Office Action Summary

10/706,098

YU, JEFF

DETAILED ACTION

FIG. 6

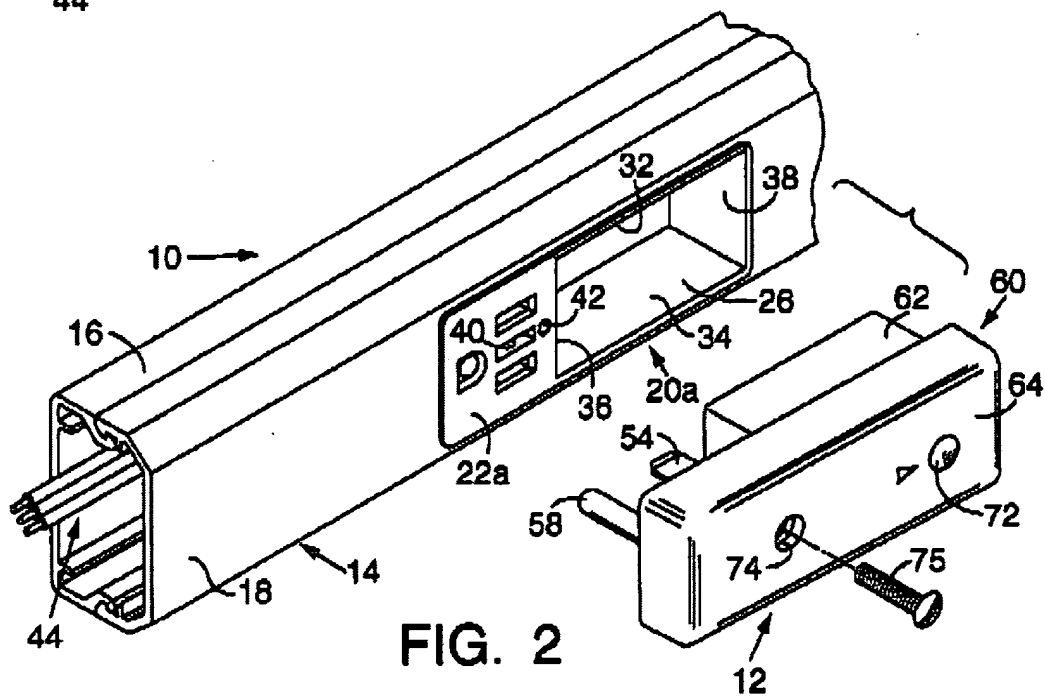
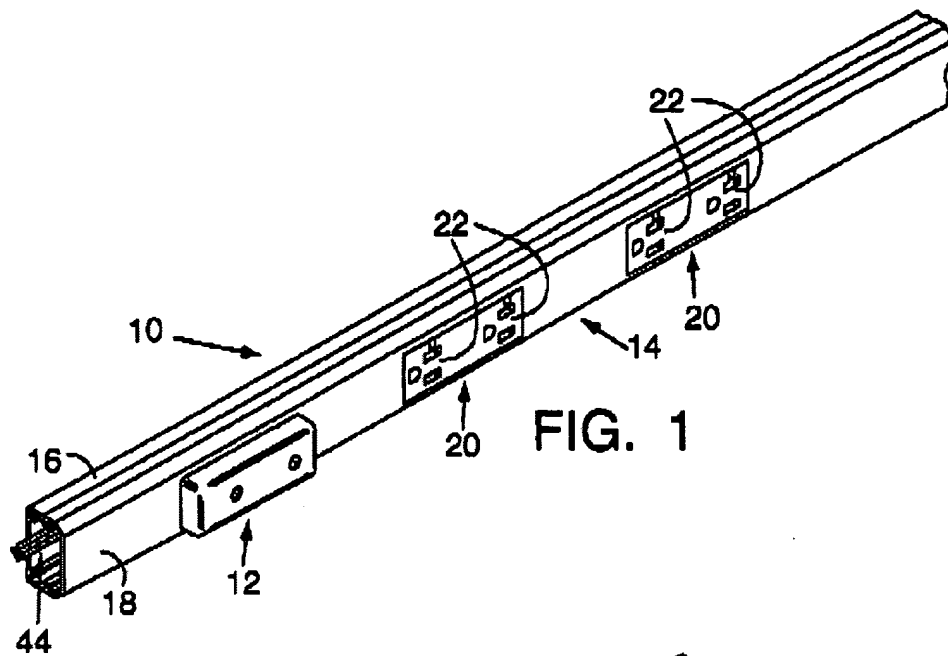
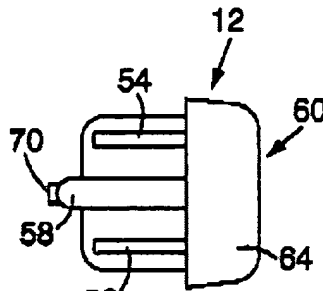
7. With regard to Claim 1, Grace et al., in Figures 1 & 2, discloses a power extension device (10) comprising: a device body including a housing (16 & 18) having at least one plug receptacle (20); said housing having a recess portion (26) for receiving a removably-attached surge protection module (60); and said module containing surge protection circuitry being configured to prevent electricity flow when removed (Column 1, lines 36-40).

8. With regard to Claim 2, Grace et al., in Figure 1, discloses the power extension device recited in Claim 1 (10) wherein the housing (16 & 18) of the device body being generally elongated.

9. With regard to Claim 3, Grace et al., in Figure 1, discloses the power extension device (10) recited in Claim 1 wherein the housing of the device body (16 & 18) being generally rectangular in shape.

10. With regard to Claim 4, Grace et al., in Figure 2, discloses the power extension device recited in Claim 1, wherein the recess portion the housing (26) of the device body being located toward a left end of the device.

12. With regard to Claim 7, Grace et al., in Figure 6, discloses the power extension device recited in Claim 1 wherein the surge protection module having four inserting prongs (54, 56, 58 & 70).

13. With regard to Claim 8, Grace et al., in Figures 1, 2 & 6, discloses a power strip device (10) comprising: a device body including a generally elongated and rectangular housing (16 & 18) having multiple plug receptacles (22); said housing having a recess portion (26) located toward an end of the device body for receiving a removably-attached surge protection module (60); and said module having positioned thereon at least one LED (71) for status indication, said module further containing surge protection circuitry being configured to prevent electricity flow when removed.

Fig-41

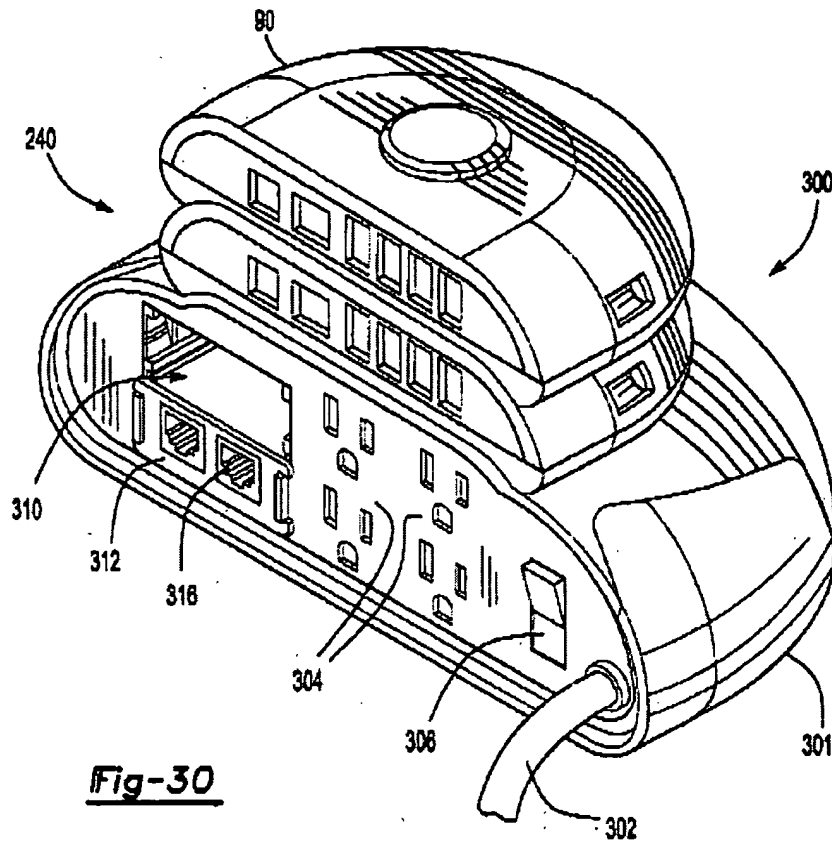
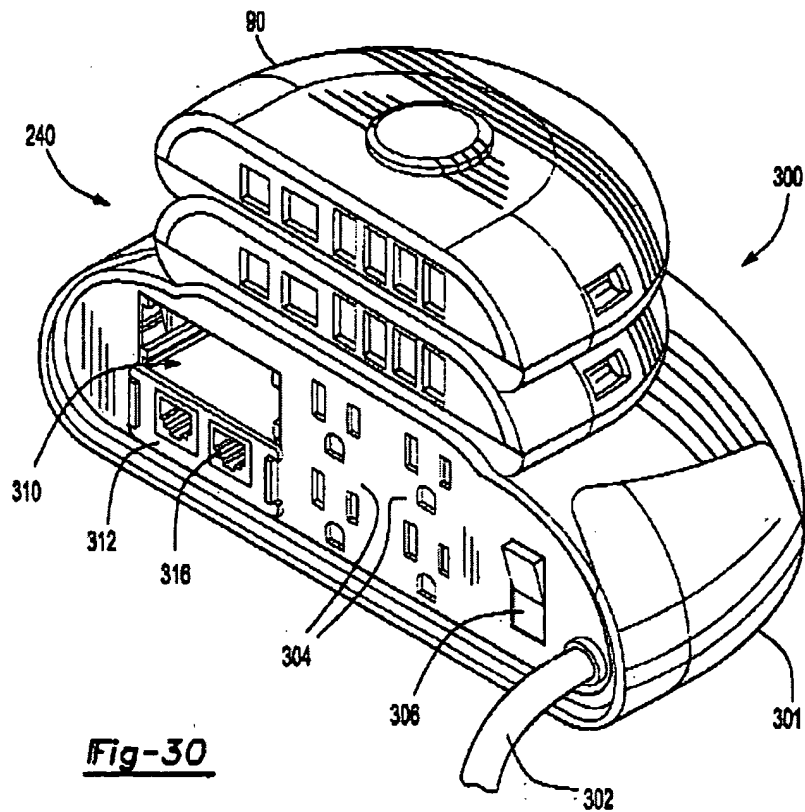
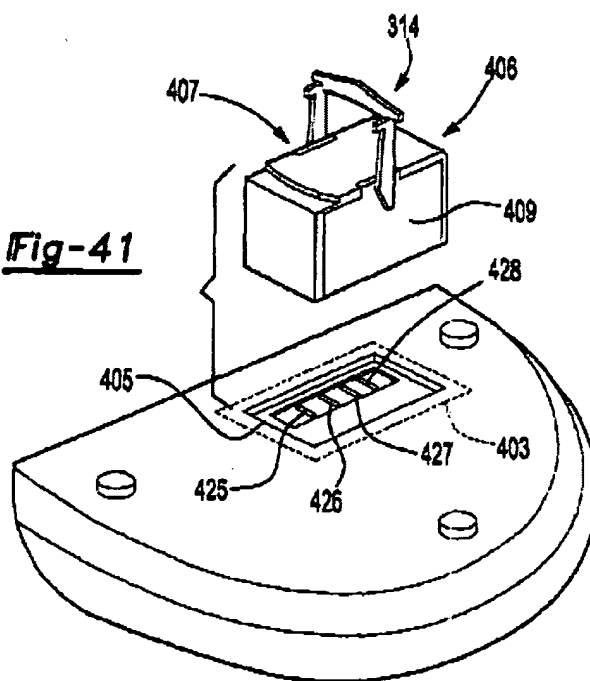
15. With regard to Claim 1, Milan, in Figures 30 & 41, discloses a power extension device (300) comprising: a device body including a housing (301) having at least one plug receptacle (304); said housing having a recess portion (310 & 405) for receiving a removably-attached surge protection module (312 & 406); and said module containing surge protection circuitry (420) being configured to prevent electricity flow when removed (column 14 lines 60-67).

16. With regard to Claim 5, Milan, in Figure 41, discloses the power extension device (300) recited in Claim 1 wherein the recess portion of the housing (405) of the device body being located toward the middle of the device.
